**REZONING, PUD &  
SUBDIVISION STAFF REPORT****Date: May 19, 2005****APPLICANT NAME**

The Quarters at Heron Lakes

REQUEST Rezoning from R-1 and R-3 to R-3, Planned Unit Development, Subdivision

# SITE PLAN

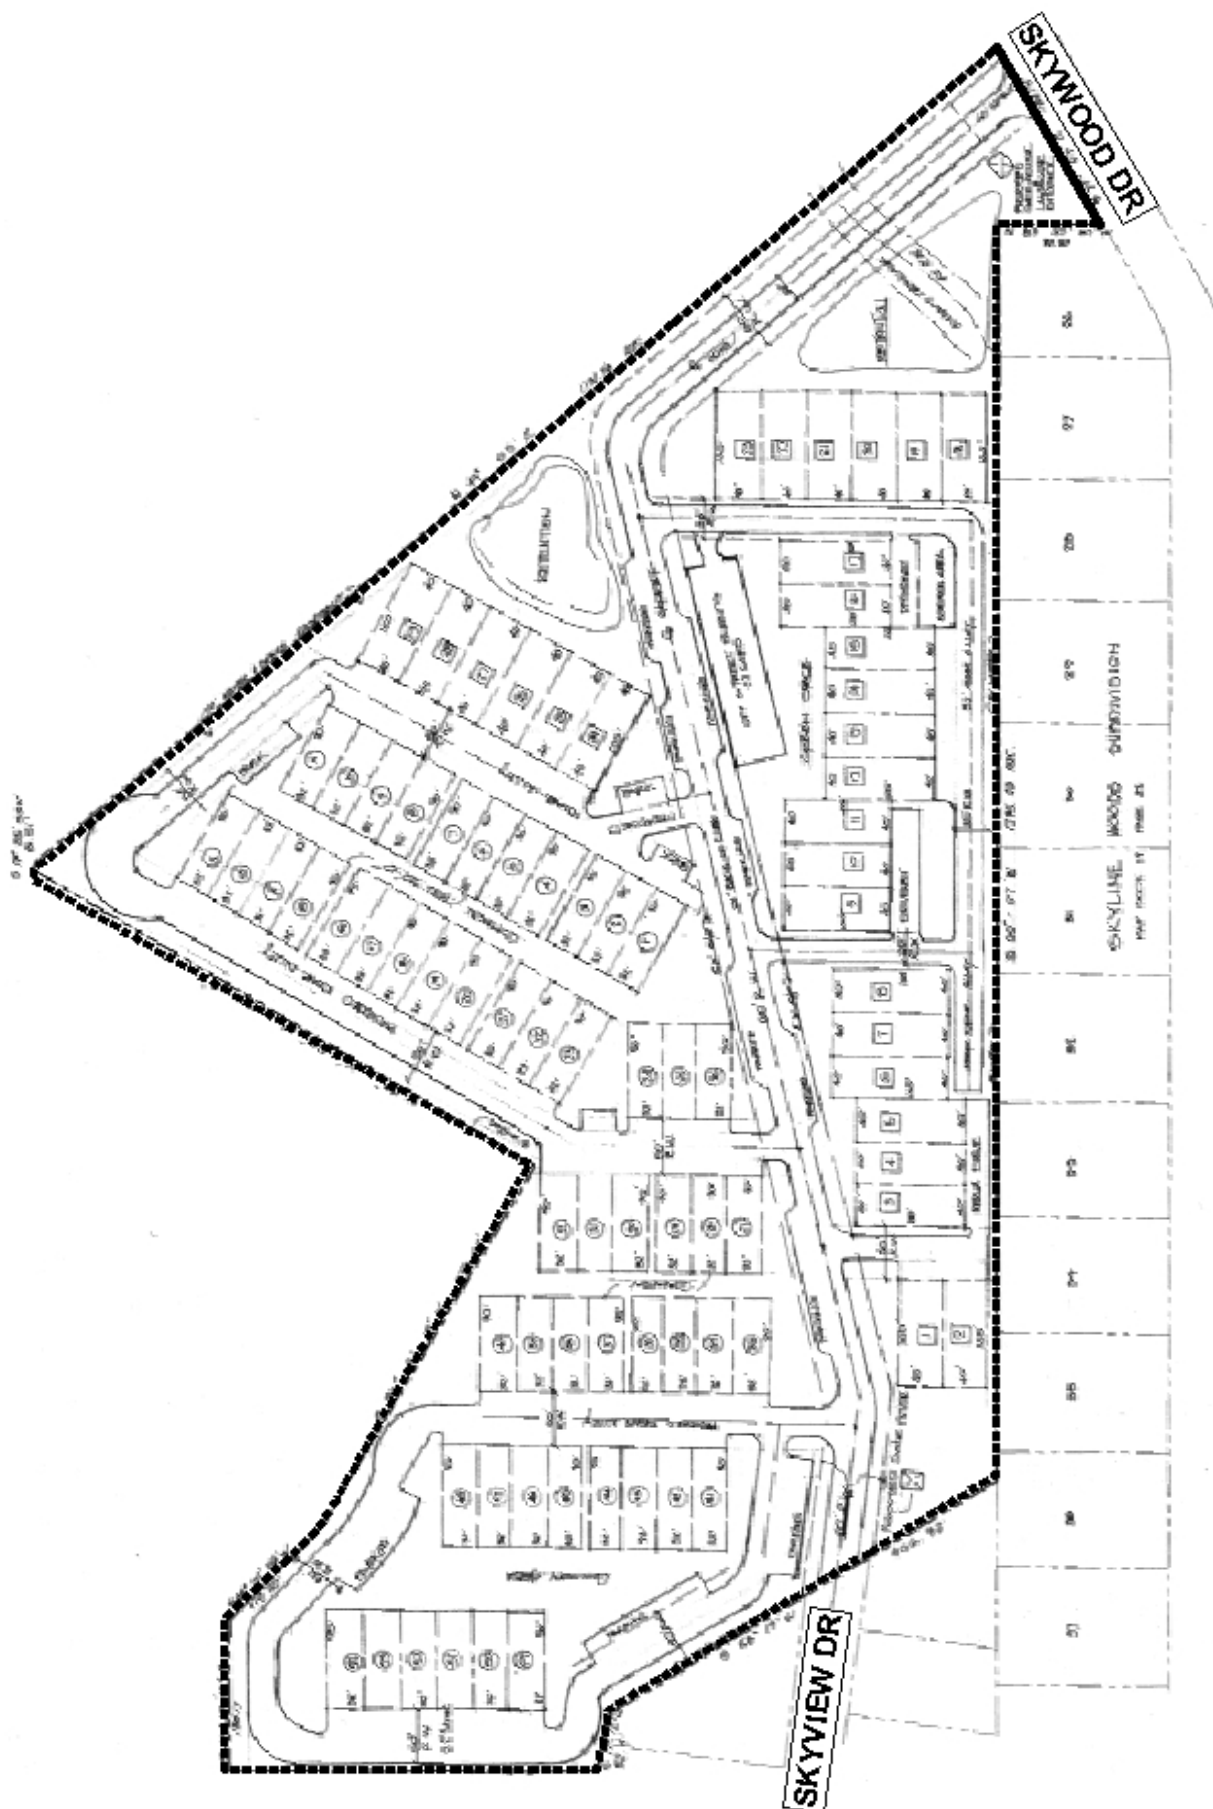
Significant, serious drainage problems existing on site and downstream. Contours not provided by applicant therefore, thorough evaluation of all problems not available. Drainage from Burma Road and significant area north of

Govt Blvd drain through site. Applicant must accommodate all existing drainage systems through site AND ensure existing outfall systems are adequate to handle the impact of the additional discharge from this development. Must comply with all stormwater and flood control ordinances. Any work performed in the right of way will require a right of way permit.

While this is an innovative development and appears to meet the general requirements for rezoning, PUD approval, and innovative subdivision approval, there were some minor issues relating to the application as originally submitted that have now been addressed. The applicant agreed that there would be no changes to the street or parking layout, unless required by engineering or the Fire Department; the side setbacks have been modified to a minimum of 3'-1" on one side and 6'-11" on the other for the single-family detached units; and, the Skyview Drive access has been changed to be a gated ingress and egress to accommodate Fire Department standard of two points of access for developments containing more than 29 residential units.

The revised comments from the Traffic Engineering Department indicate that signalization of Skywood Drive at Government Boulevard may not be necessary with the second point of access, but geometric changes may be needed at that intersection.

**Planned Unit Development:** based on the preceding, it is recommended that this application be approved subject to the following conditions: 1) completion of the rezoning and subdivision processes prior to the issuance of any permits; 2) development to be limited to the revised plan showing Ingress and Egress to be via gated access to Skywood Drive and Skyview Drive, and detached single-family dwelling side setbacks of 3' on one side and 7' on the other, and 83 lots; 3) full compliance with Engineering Department comments (Significant, serious drainage problems existing on site and downstream. Contours not provided by applicant therefore, thorough evaluation of all problems not available. Drainage from Burma Road and significant area north of Govt Blvd drain through site. Applicant must accommodate all existing drainage systems through site AND ensure existing outfall systems are adequate to handle the impact of the additional discharge from this development. Must comply with all stormwater and flood control ordinances. Any work performed in the right of way will require a right of way permit.); 4) full compliance Urban Forestry Comments - for the overall development (Property to be brought into full compliance with landscape and tree requirements of the zoning ordinance. Property to be developed in compliance with state and local laws that pertain to tree preservation and protection on both city and private properties [City Code Chapters 57 and 64 and State Act 61-929]); 5) submission of a revised drawing to reflect access and setback changes (for file copy); and 6) full compliance with all municipal codes and ordinances.

**Subdivision:** based on the preceding, it is recommended that the subdivision be considered under Section VIII as an innovative subdivision to allow the gated, private street and alleys, reduced lot sizes (Section V.D.2), and be granted Tentative Approval for 83 lots, subject to the following conditions: 1) compliance with Section VIII.E.2 of the Subdivision Regulations for private streets (minimum standard); 2) gates to remain functional (the gate to remain operational and in use, if gate ceases to be used, the street must be brought into compliance with city standards and dedicated to the city); 3) full compliance with Engineering Department comments (Significant, serious drainage problems existing on site and downstream. Contours not provided by applicant therefore, thorough evaluation of all problems not available. Drainage from Burma Road and significant area north of Govt Blvd drain through site. Applicant must accommodate all existing drainage systems through site AND ensure existing outfall systems are adequate to handle the impact of the additional discharge from this development. Must comply with all stormwater and flood control ordinances. Any work performed in the right of way will require a right of way permit.); 4) all areas not designated as placement of a note on the final plat stating that maintenance of all common areas and detention facilities shall be the responsibility of the property owners; 5) completion of the rezoning process prior to the issuance of any permits; and 6) placement of a note on the final plat stating that development limited the accompanying (amended) PUD.
